LATHAN
ARCHITECTS
LATHAN ■ BRYANT ■ CALMA

ADDENDUM NO. 2
ADDITION AND RENOVATION FOR FLOMATON ELEMENTARY SCHOOL
PACKAGE A: MEDIA CENTER AND CLASSROOM ADDITION
DCM NO. 2021011 PSCA NO. 9167
Architect Job No. 21-04A
March 29, 2022

The Plans and Specifications are hereby amended. The following supersedes all contrary and/or conflicting information and is made part of the contract documents.

1 BASE BID LIFE SAFETY PLAN

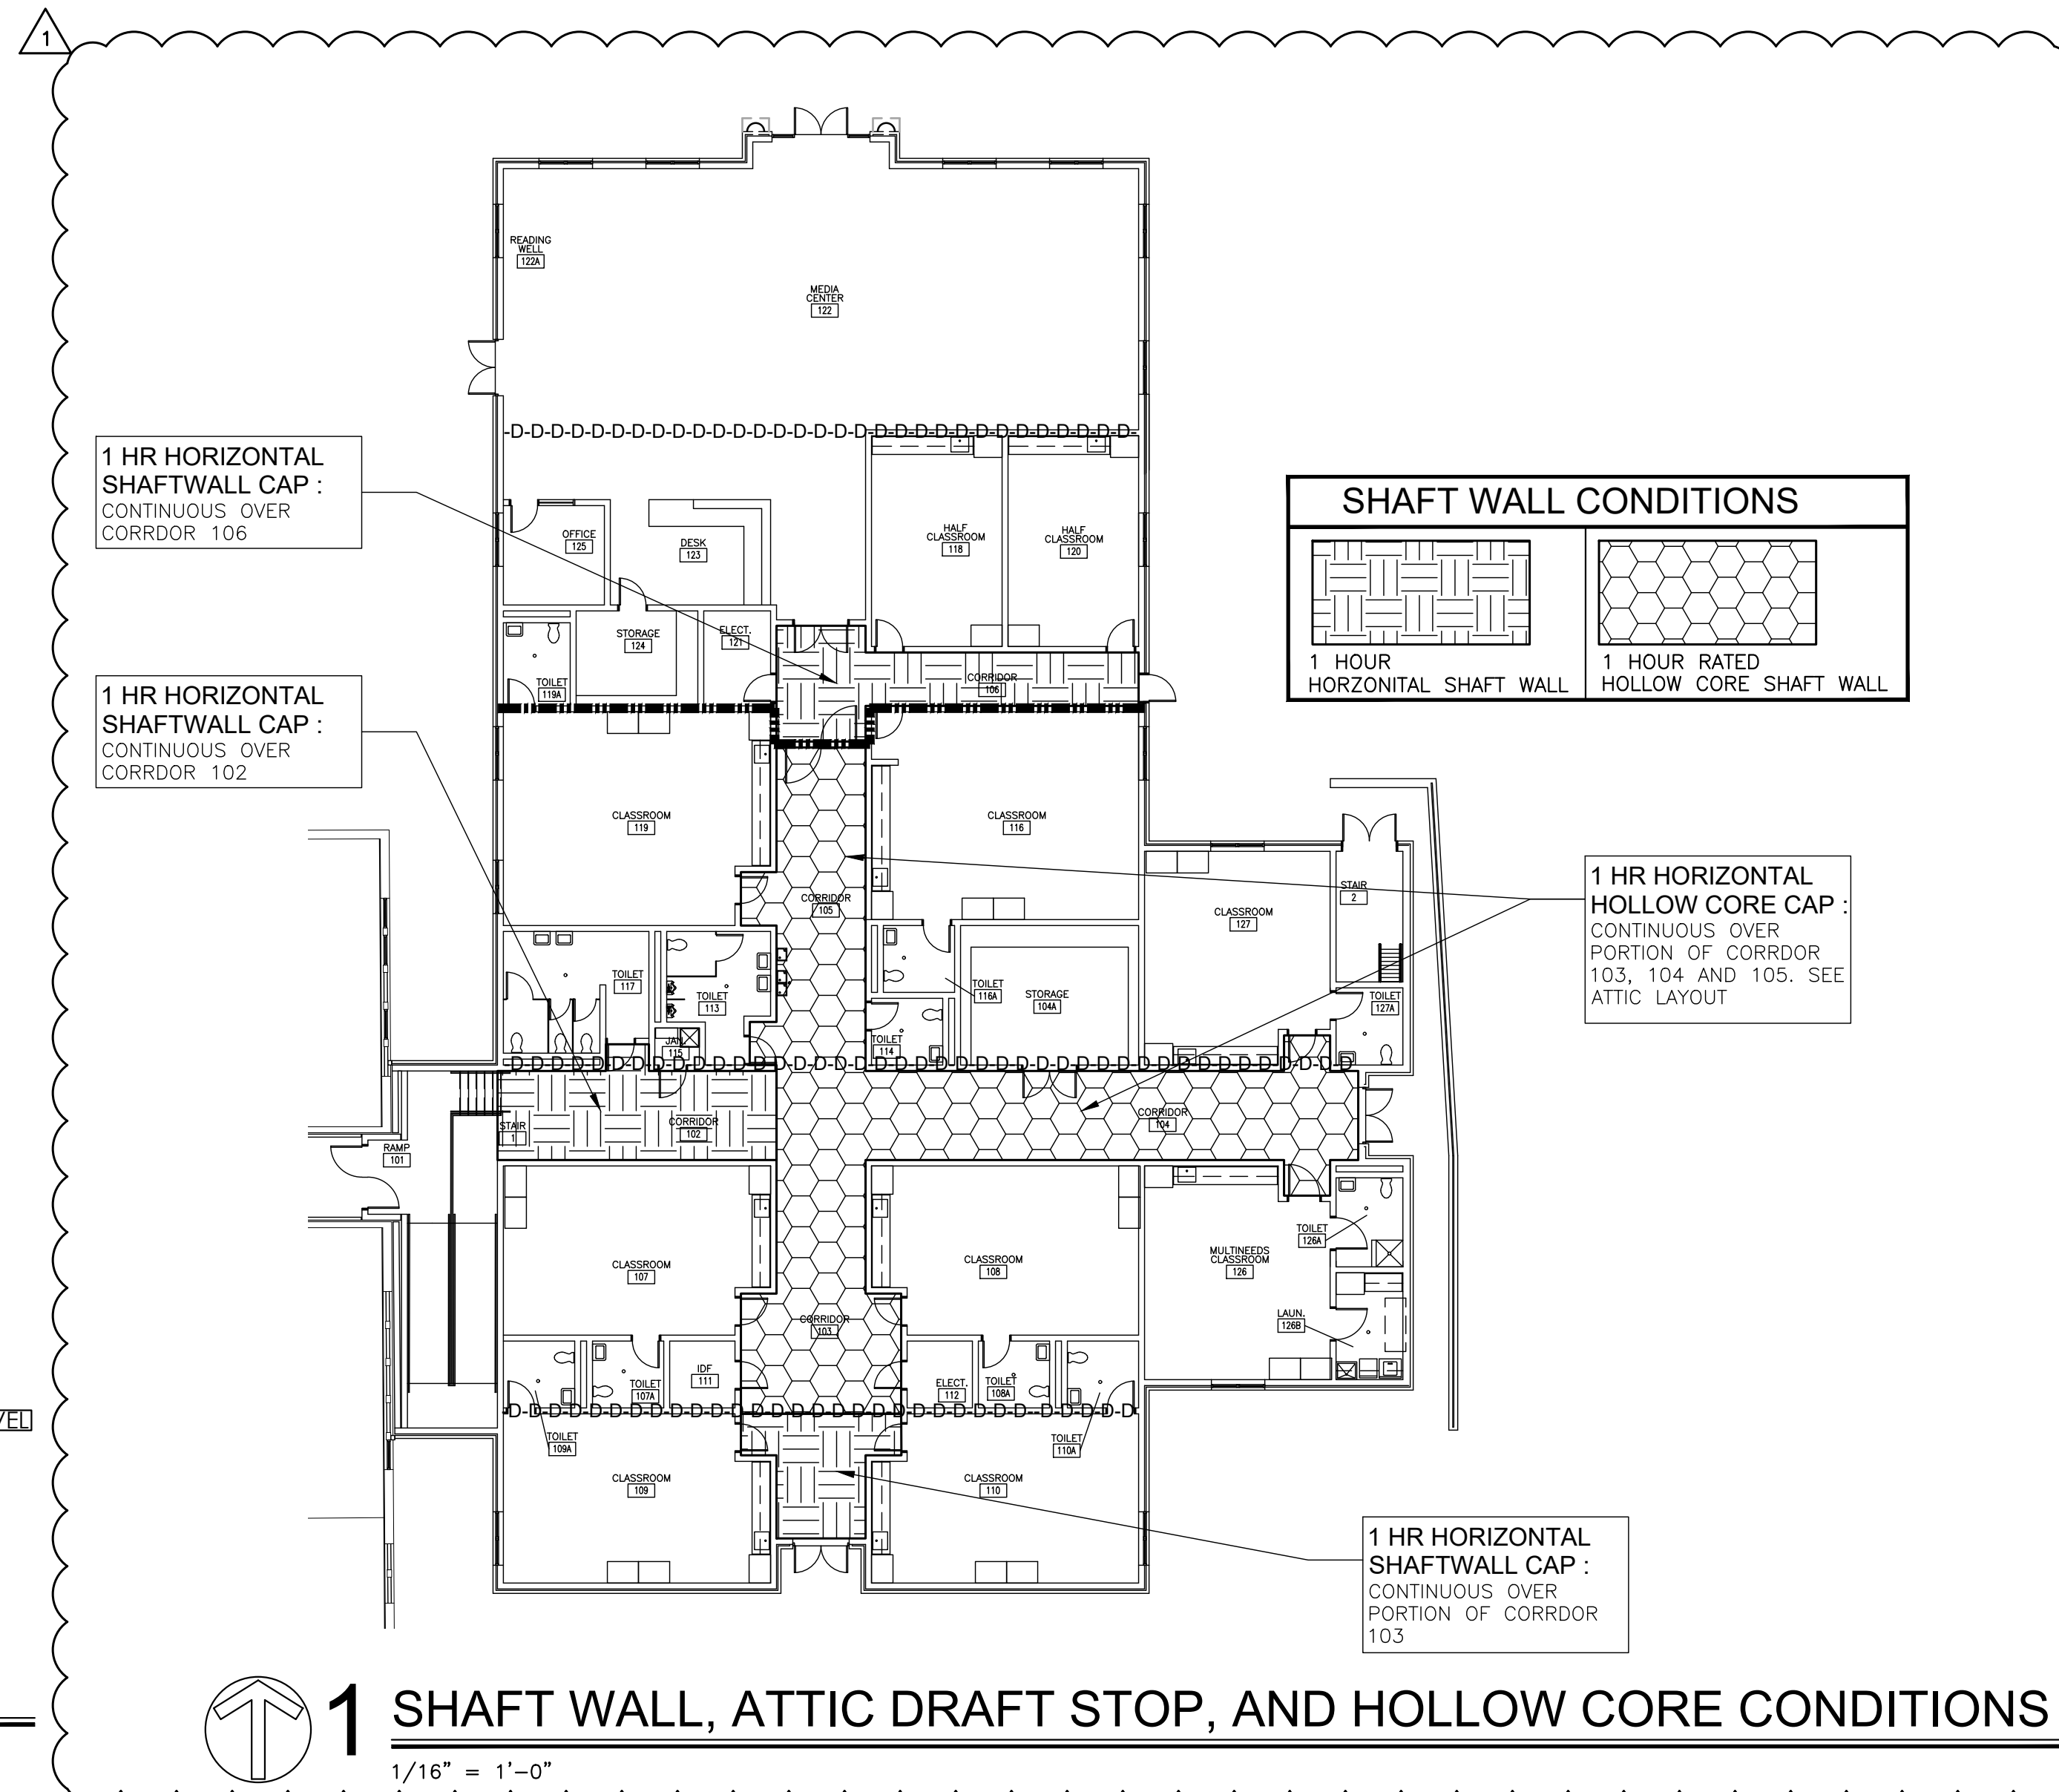
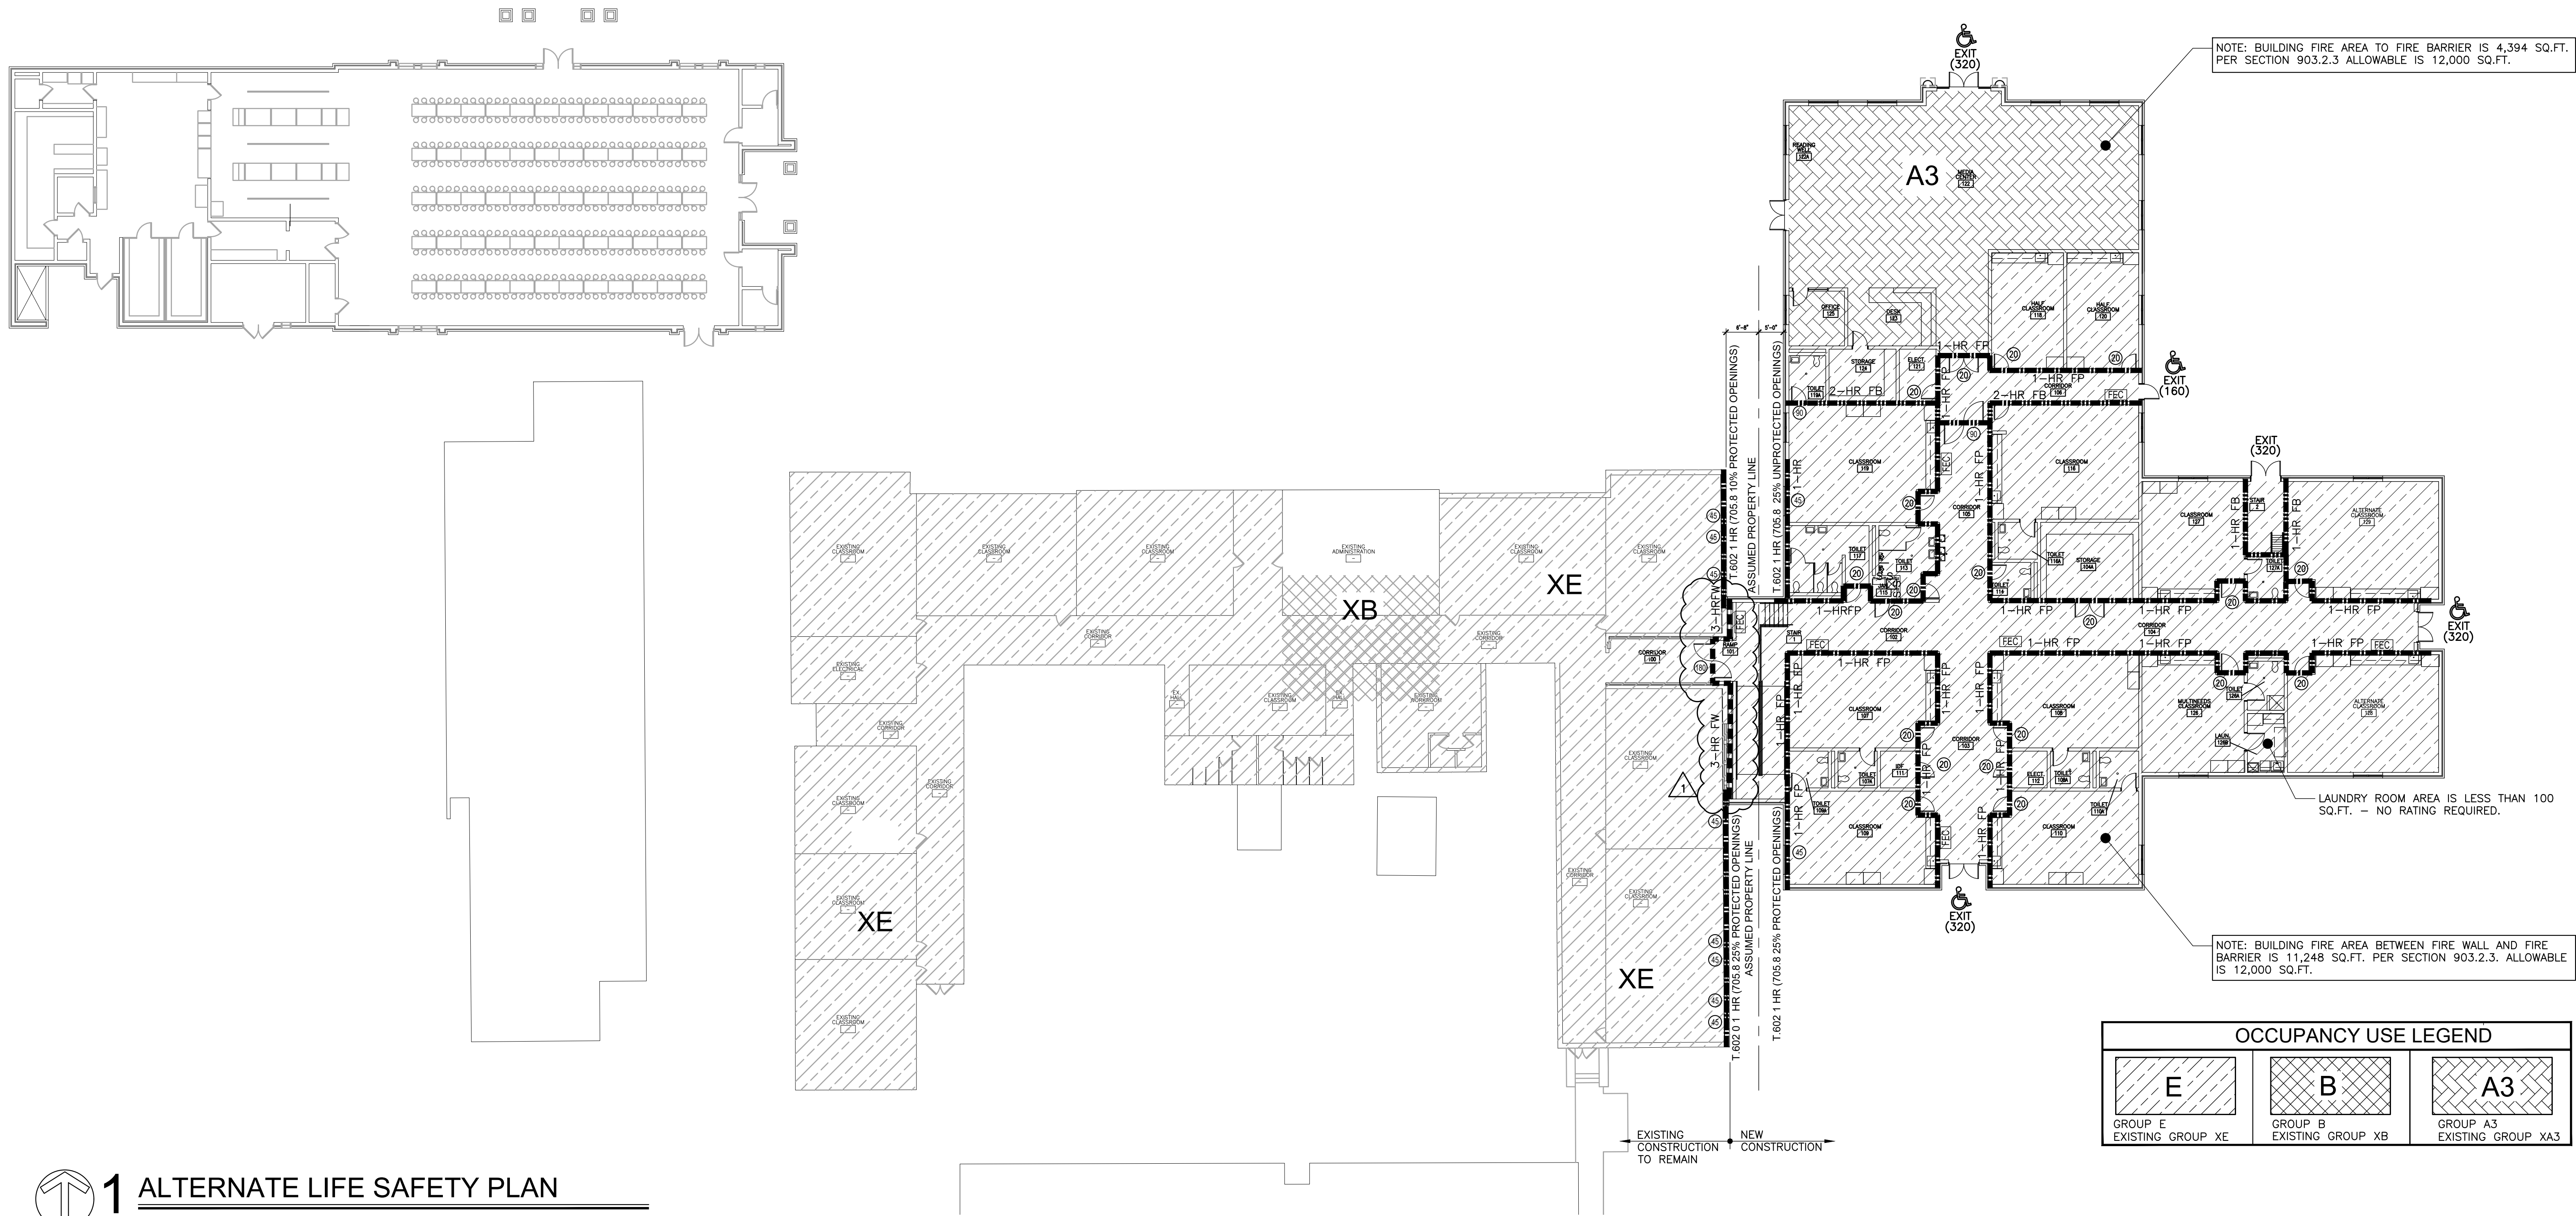
1. LS1.1 – Base Bid Life Safety Plan – See revised Shaft Wall, Attic Draft Stop, and Hollow Core Conditions for the addition of Attic Draft stops and the modification of the fire wall between existing and new construction to 3 - hours.
2. LS1.2 – Alternate Life Safety Plan - See revised Shaft Wall, Attic Draft Stop, and Hollow Core Conditions for the addition of Attic Draft stops and the modification of the fire wall between existing and new construction to 3 - hours.
3. A2.1 – Base Bid Floor Plan – see the new refrigerate line detail and increasing the fire door and from 90 to 180 minutes.
4. A2.3 – Attic Floor Plan – See the additional pair of doors in the attic for the draft stop assembly.
5. A2.7 – Door and Window Schedule and Details – see the modified fire door increased from 90 to 180 minutes.

1 MECHANICAL PLAN

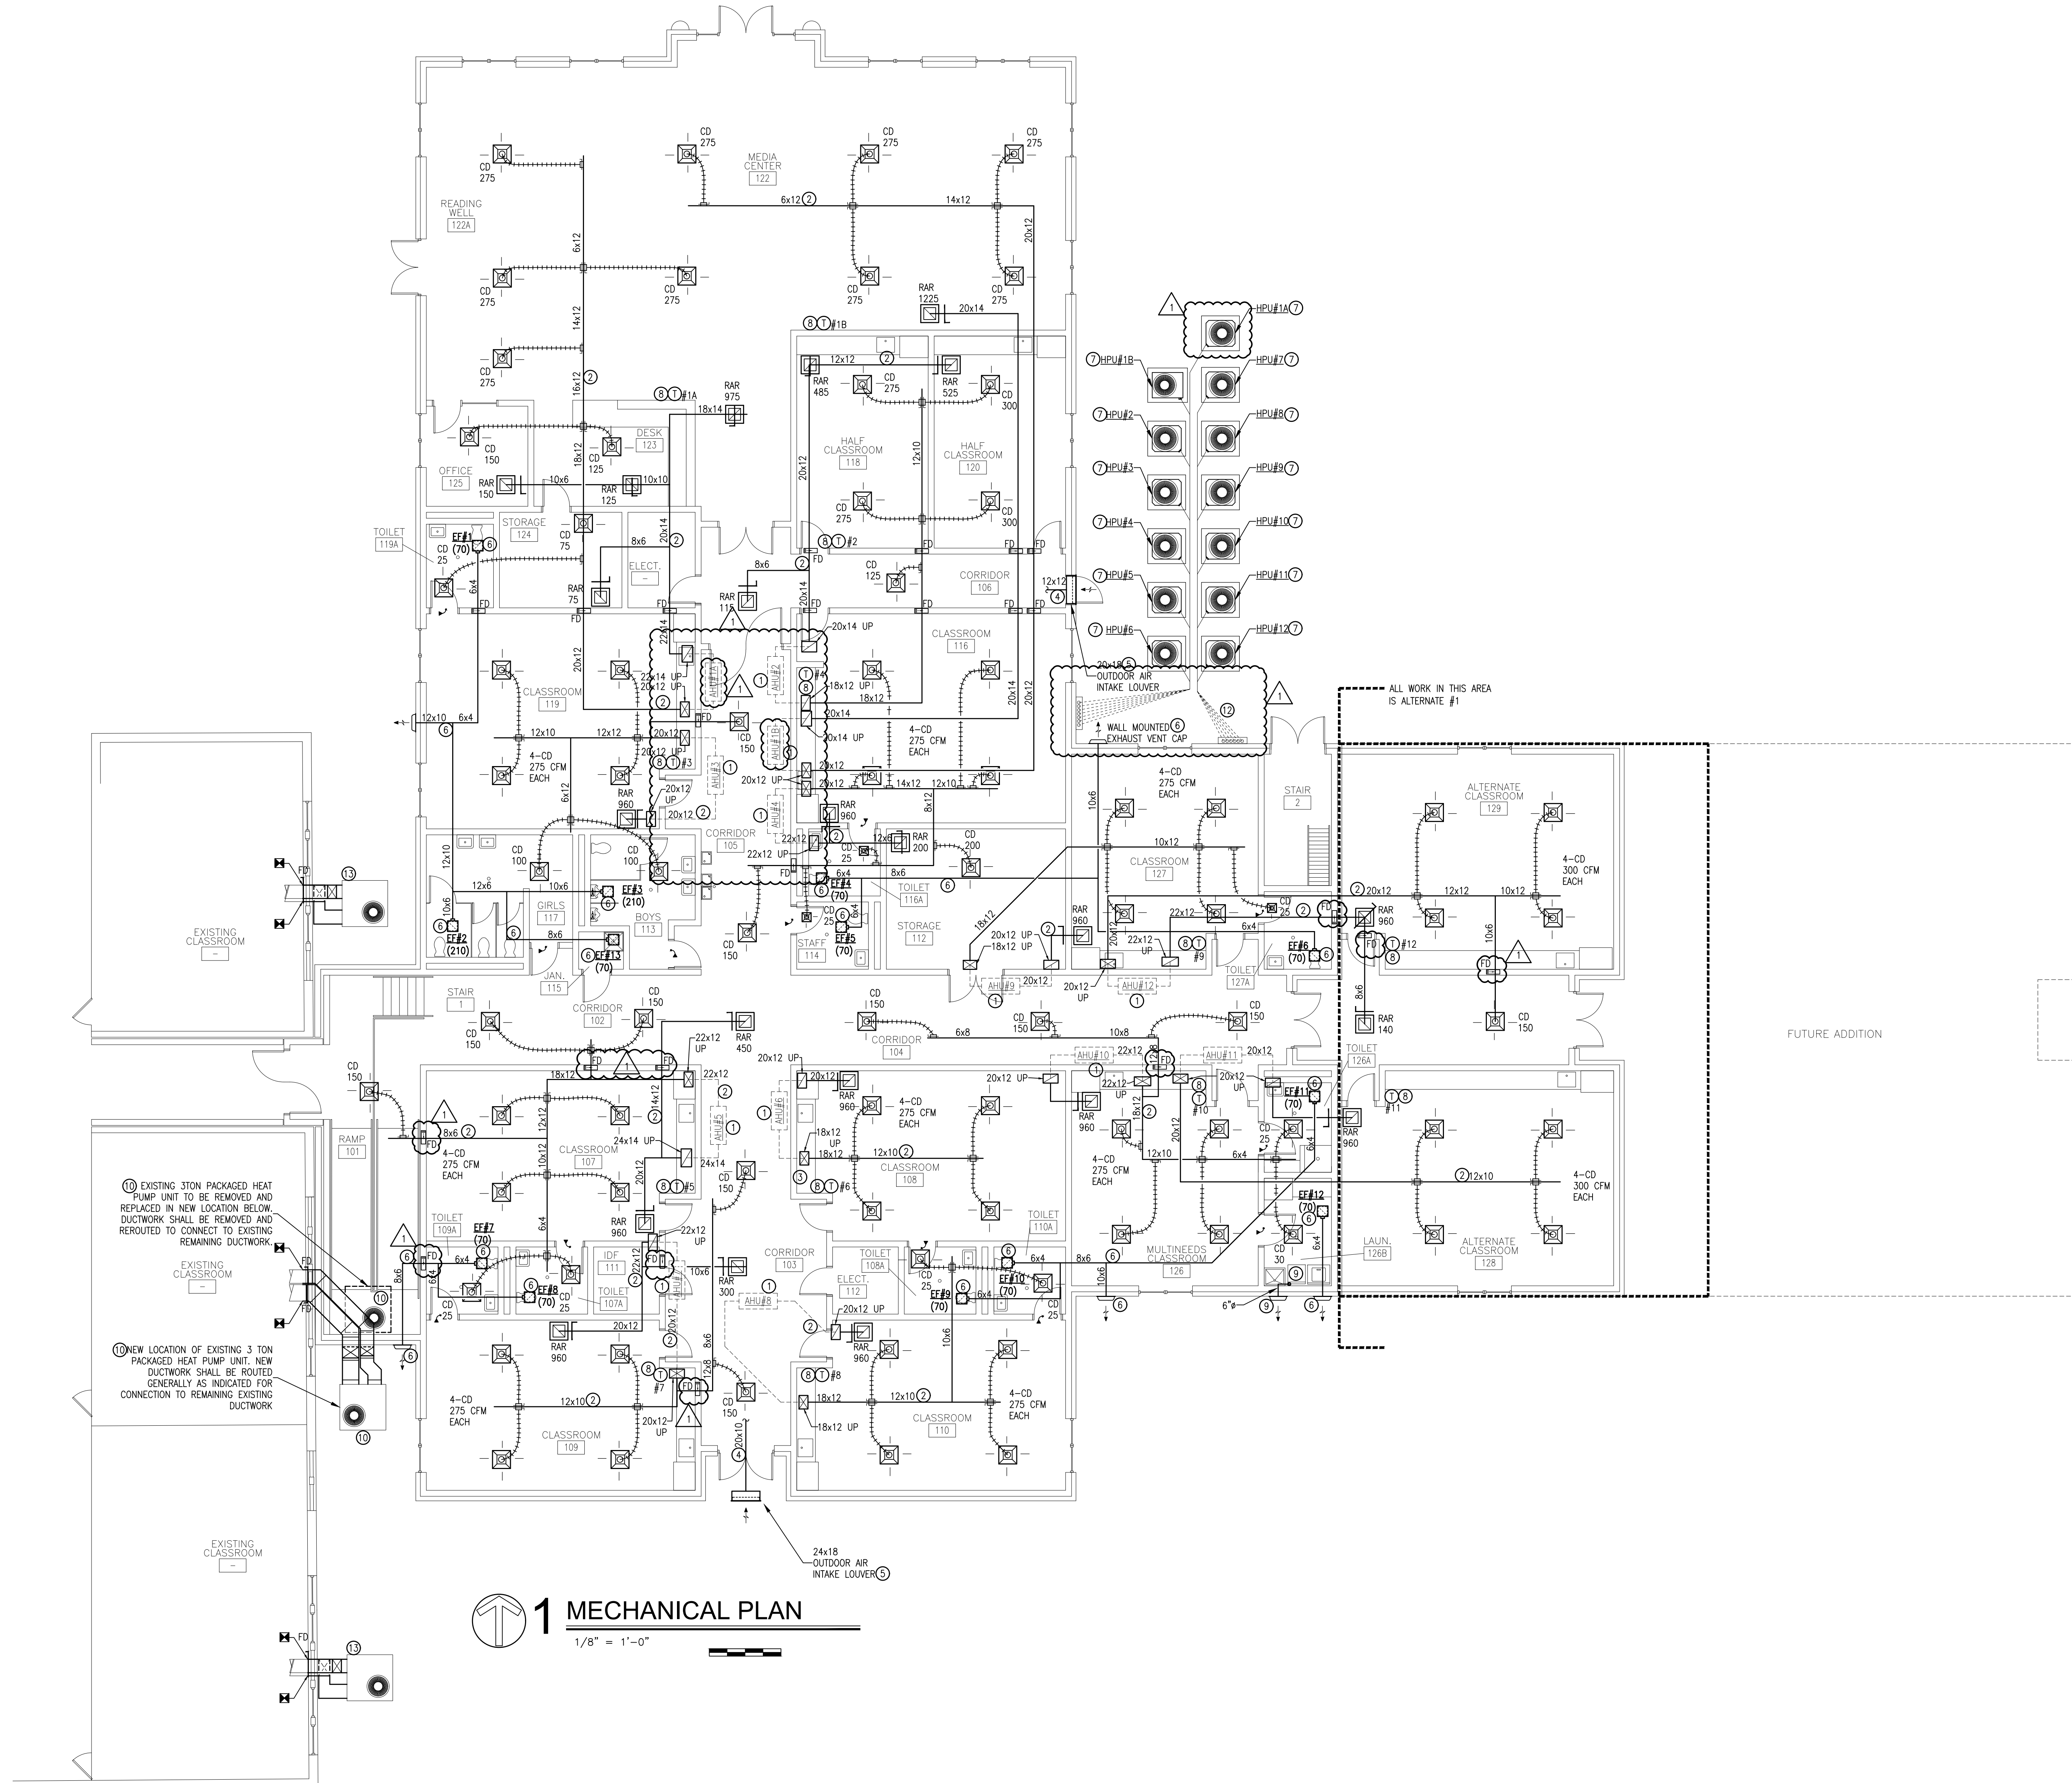
1. M1.1 – Mechanical Plans – added sizing of AHU#1 supply air duct, showed routing of refrigerant lines from outdoor to indoor equipment, and routing of ductwork and air handling equipment has been clarified.

6. Sizes of supply and return air ductwork have been adjusted to accommodate field conditions.
7. Mechanical sheet M1.1 and M1.2 have been revised to clarify equipment locations with routing of ductwork. This particularly applies to the outdoor air intake ductwork.
